RECOMMENDATION

2100 E. DENNY WAY
SEATTLE, WA 98112

3036655-LU **TAXUS HOUSE APARTMENTS**
ADMINISTRATIVE DESIGN REVIEW

^ Updated Architectural Site Plan
< Recommendation View of Massing

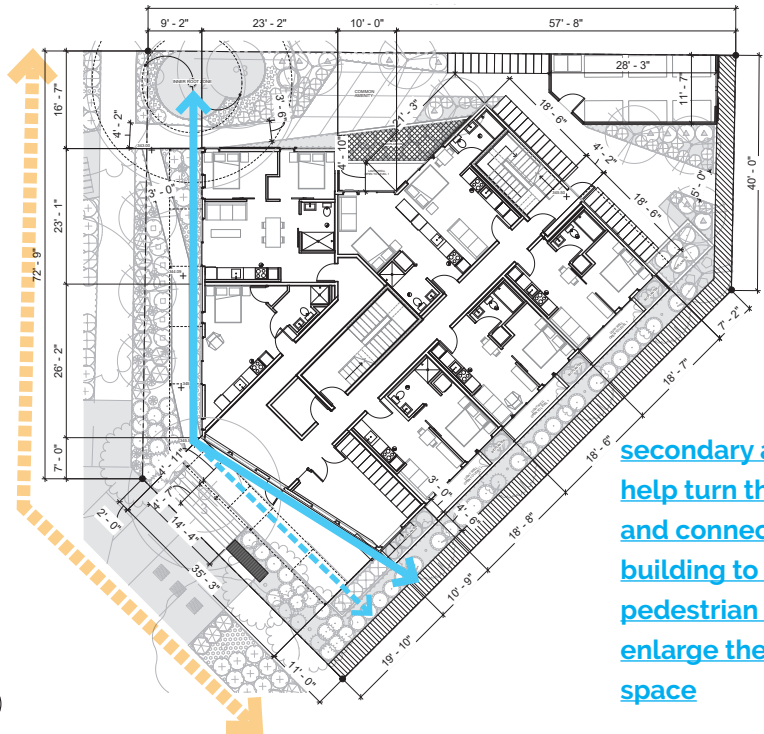
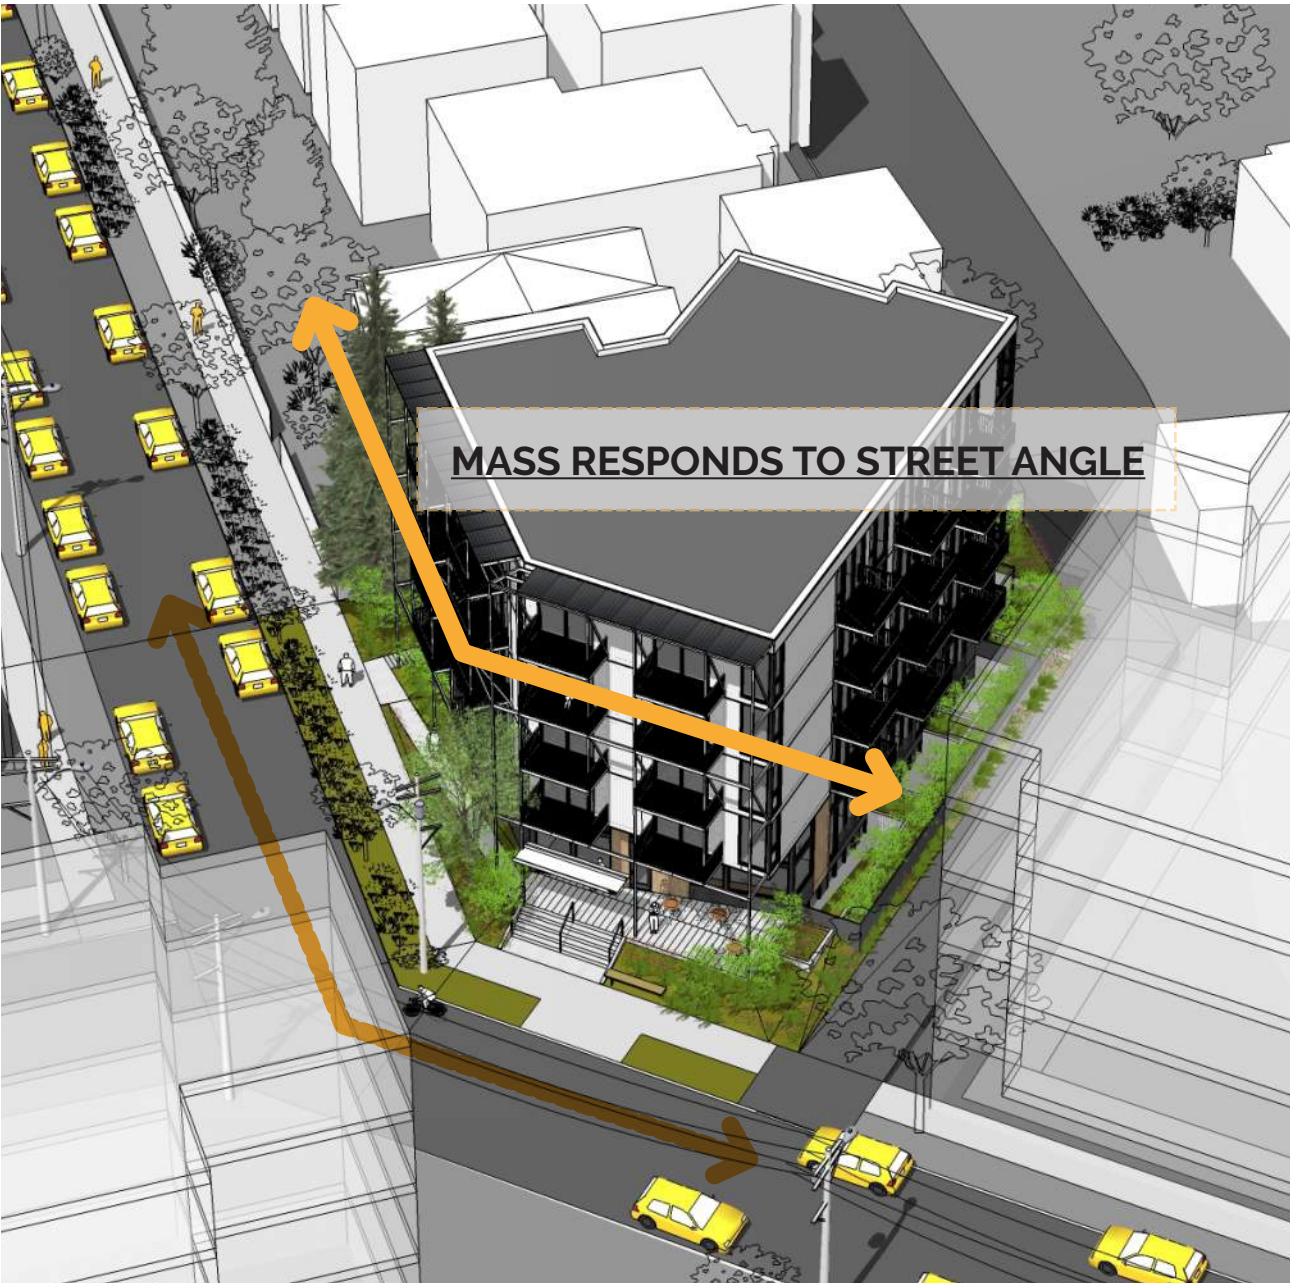
The Board supports Massing Option#3 as it employs a clear concept and takes advantage of the unique characteristics of the site.

The design of the proposed building has been developed to maintain a clear and articulate massing concept that responds to the angular condition of the corner site. The street-facing mass specifically along E Denny Way and 21st Avenue East successfully navigates the bend in the street and provides a terminus to the view corridor looking east from E. Denny Way. This simple and angular move, turns the corner while being a distinctive architectural form that helps connect to the street. This is how the building is interacting with the physical features and public realm at the sidewalk through its massing and architectural concept.

Further, articulation of the angular distinctions provided by the street condition can be seen in the site plan development. To open up the front of the building, more to the public realm and to enhance the front porch of the design, another angle is introduced to further enhance and welcome visitors and residents.

The building mass itself has been set back from the street to allow room to connect the front door of the building to the public sidewalk and to allow semi-public space at the front porch. Generous ramps and landscaping further provide pleasant opportunities for public amenity and visual delight.

EDG ENTRY

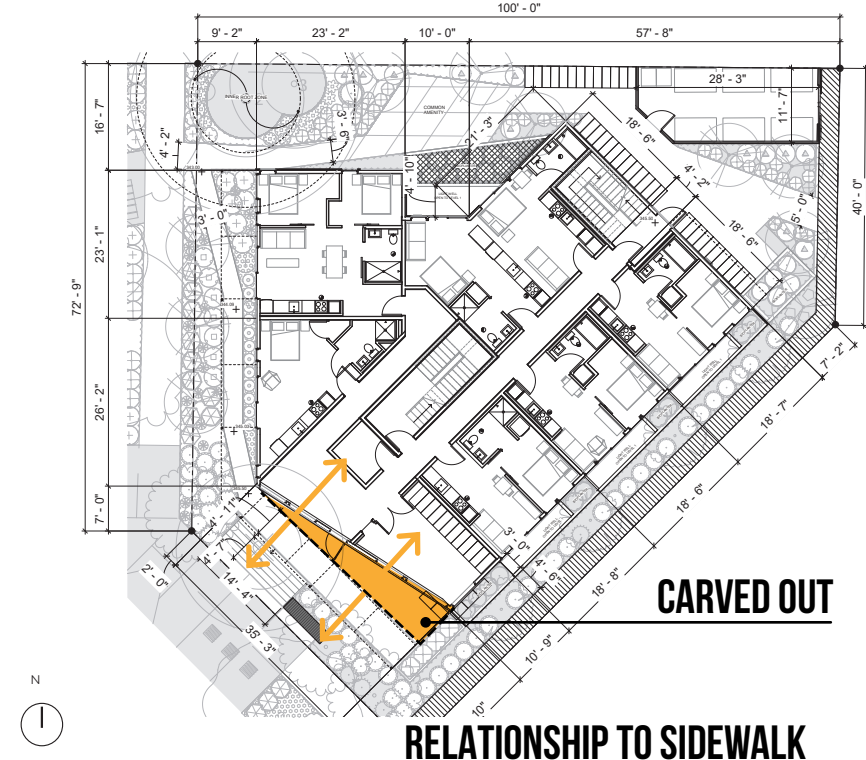
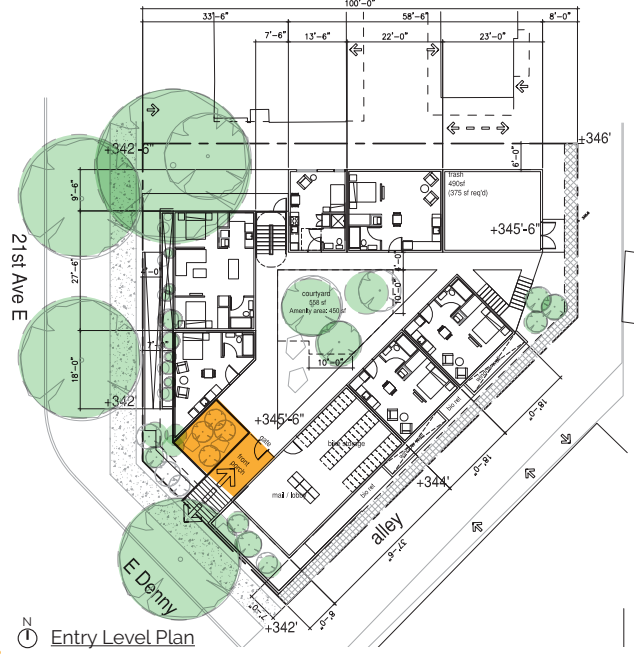
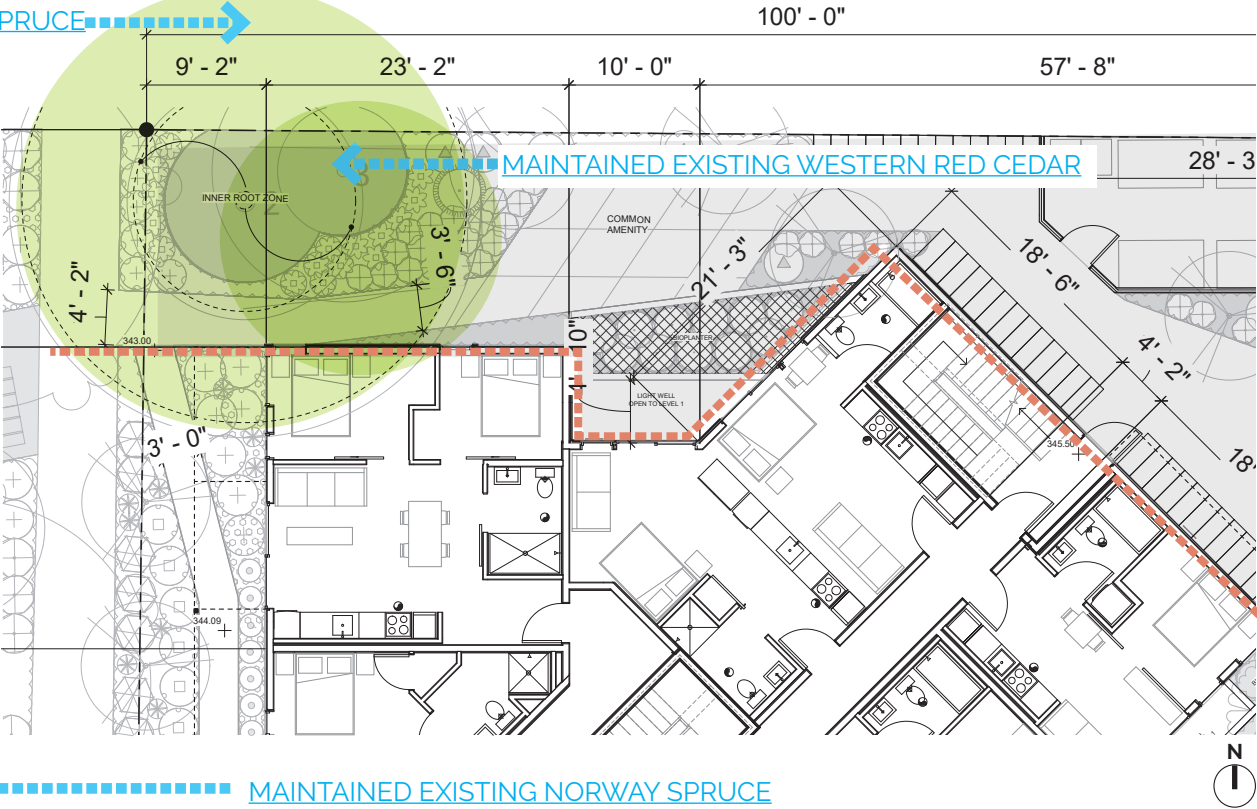
b. Staff supports the intent to carve out a "front porch", which the Central Area Design Guidelines pronounce as the "life of the street." Staff, however, notes that the entry portal in Option 2 is more open and spacious, and emphasizes the corner and unique configuration of the site. Further develop the entry portal in Option 3 to achieve these qualities. Minimize the presence of planters and other obstructions. Design the space to promote social interaction. Staff specifically prioritizes Citywide Design Guideline PL3 Street-Level Interaction, and Central Area Design Guideline PL3-2-i, Porches and Stoops. (PL3, PL3-2-i)

The developed recommendation design continues to build upon the concept of carved our mass along the lower level to create an entry portal that is inspired by the angular quality of the streetscape. While previously in EDG the mass seemed more like a recess or "bite" out of the mass, the revised design recesses the porch through the use of an angle, creating a larger front porch and portal to the new building.

Additionally the wider front porch and adjacent common room also will promote more street level activity and visual interest through the covered entry, seating on the porch area and a direct connection to the sidewalk through the use of a long, landscaped ramp on the west facade and new entry stairs at the southwest corner of the site. Adjacent to these new stairs is additional seating for residents and guests to use to wait for a ride share or delivery.

Plan view showing the location of the Juliette balcony

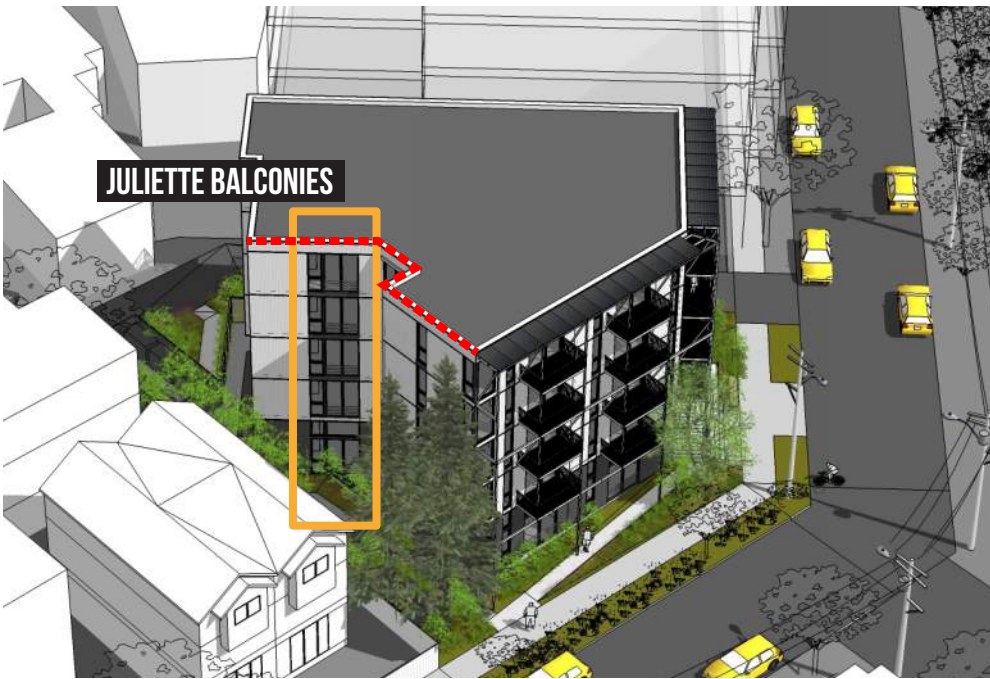
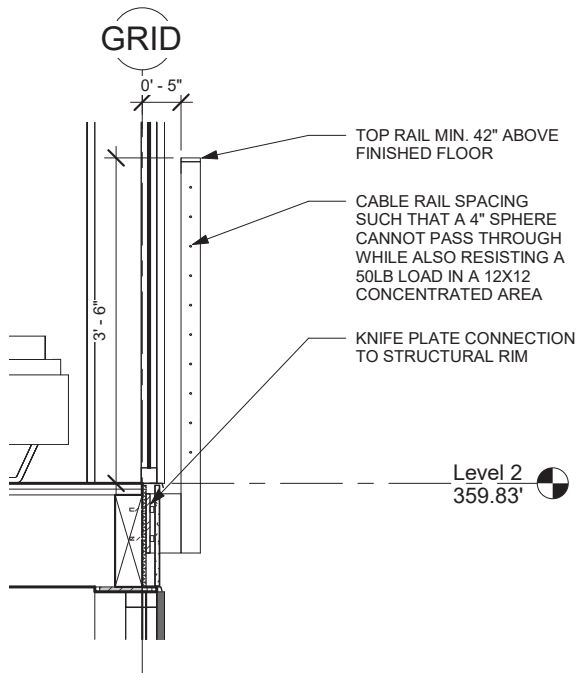
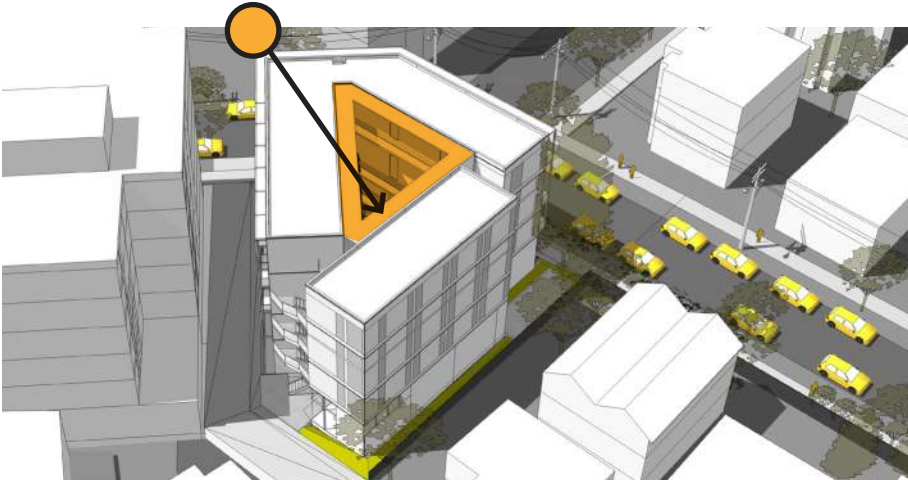
b. In addition to the strategic massing moves along the street and alley edge, secondary architecture features have been utilized on all facades to promote a residential character for the proposed building. While larger, exterior balconies and armature are utilized are the street facing edge, the design allows each facade to respond respectively and uniquely to the surrounding conditions. The alley facade incorporates exterior balconies as well, but an approach on the north facade maintains a similar fenestration and material character with greater respect for the adjacent townhouse site on the north.

The Juliette balconies proposed on this facade, maintain a similar access to light, air and open space, while adding visual interest /texture to the facade in keeping with the architectural aesthetic expressed.

Interior Courtyard - Rendering

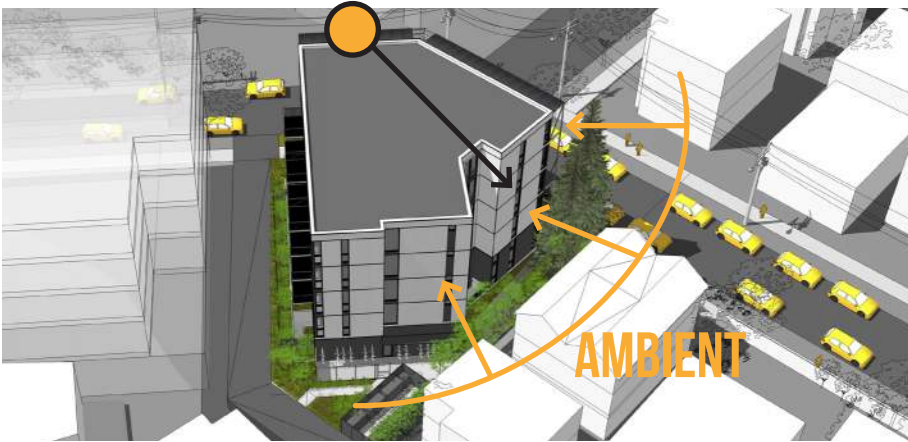
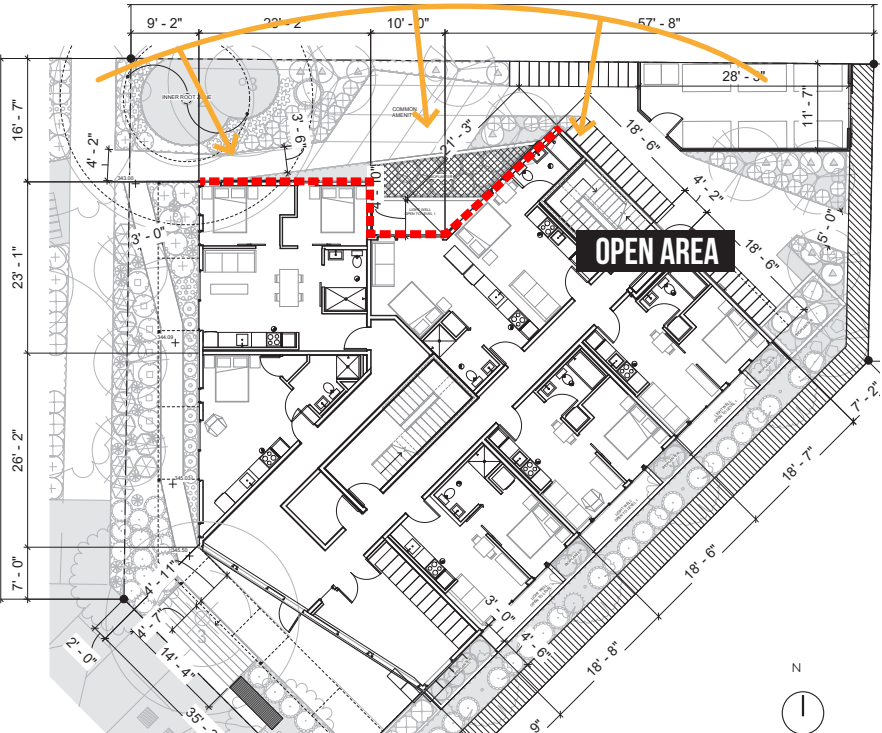
The Board expressed concerns regarding the access of natural light in the deep central courtyard and further suggested exploration.

c. Staff notes that the deep central courtyard will frequently be in shade/shadow. Explore how the structure of the external corridors and materiality can be used to lighten the space. To maximize daylight, consider eliminating the continuous overhead weather protection at the top level. Staff specifically prioritizes Design Guideline CS1-B-2, Daylight and Shading. (CS1-B-2, DC2-A-1, DC3-B-2, DC4-A)

c. The design has been developed to respond to staff guidance by eliminating the central courtyard, which provided limited daylight and excessive exterior circulation. By collapsing the massing and redefining the amenity area as a buffer that could be articulated on the north side of the project, the new design aspires to provide sunnier and more practical / usable amenity area for the residents of the new design. This amenity and circulation path also allows visitors and guests to access the trash and bike storage / alley the the other edge of the site.

Shadow Studies: June, 9 A.M.

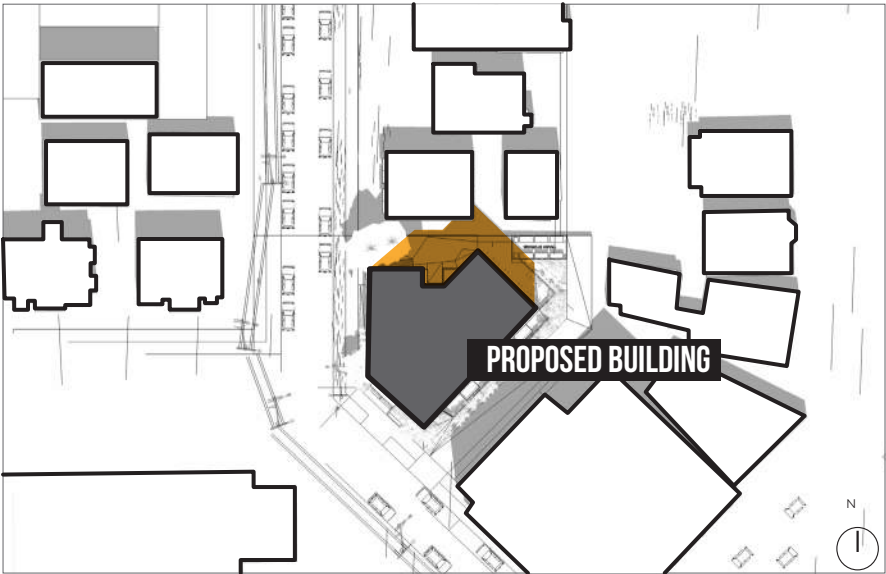
The Board appreciates the privacy studies applicant provided in the EDG packet and requested an updated privacy study in the REC packet with the consideration of noise and lighting impacts to the adjacent site to the north.

e. Staff appreciates the privacy studies provided on page 53 of the EDG packet. Minimize privacy impacts as the design evolves and provide an updated privacy study in the Recommendation packet. Consider the noise and lighting impacts of the north stairwell on the adjacent site. (CS2-D-5)f. The Board specifically prioritized PL3-A, Entries, and PL3-B, Residential Edges. (PL3A,PL3-B)

e. The design team has noted the privacy studies requested by the staff. The developed design endeavors to further provide a greater respect and landscaped buffer for the adjacent townhouses on the north edge of the building site. By removing the courtyard as proposed during EDG, the design relocated all the open space to the edge of the project, furthering respecting adjacent sites. Through this design move, the existing matures trees are preserved on the northeast corner of the site. See the updated privacy and solar studies below. The additional green space is utilized to transition new development from existing construction.
